SAN DIEGO BAY COUNCIL

March 21, 2005

RE: San Diego Bay Council Additional Comments on NPDES Nos. CA0108073 and CA0108181,
Tentative Orders No. R9-2005-0005 and R9-2005-0006, Southern California Edison San
Onofre Nuclear Generating Stations (SONGS) Units 2 and 3

Figure 1

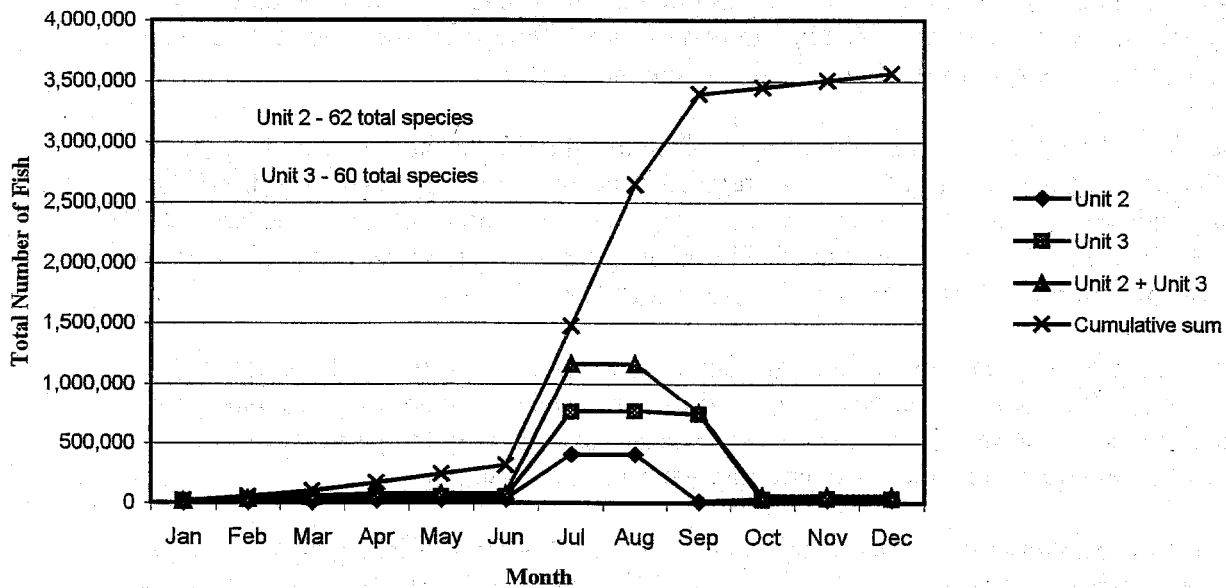
The document review package contained the SCE 2003 Annual Marine Analysis and Interpretation report. This report provided limited information on the outfall and intake configuration and the outfall diffusers. The report also included the estimated 2003 monthly count and weight of fish impinged fish at Units 2 and 3. Page E-42 of the Fact Sheet in the Tentative Order cites fish impingement data for Unit 2 without providing the data source. However, the SCE data shows that this data is for Unit 3. The Fact Sheet should provide the estimated combined fish impingement and entrainment from Units 2 and 3, not just one unit. For your information we have used the SCE data and provide the estimated monthly count and weight of fish impinged in 2003 at Units 2 and 3 and the combined totals for both units in Figures 1 and 2 are shown on the next page. The data reveals a strong seasonal influence, with highest fish losses in the summer months. It also shows that Unit 3 takes a much larger toll on the fishes than Unit 2; the 2.58 times more in the number of fishes and 2.88 times more in weight of the fishes. We have no explanation for this. The combined fish counts and weights are shown as the cumulative sums. The estimated total count of fishes impinged is 3,564,433. The estimated total weight of the impinged fish is 21,923 kilograms (48,231 pounds).

We recommend that the *Comprehensive Demonstration Study* investigate the large difference between the estimated number and the weight of the impinged fishes in Units 2 and 3 even though that intake flows are basically the same. We recommend the study determine the predation losses of the fishes returned to the ocean and sample the health of the returned fish.
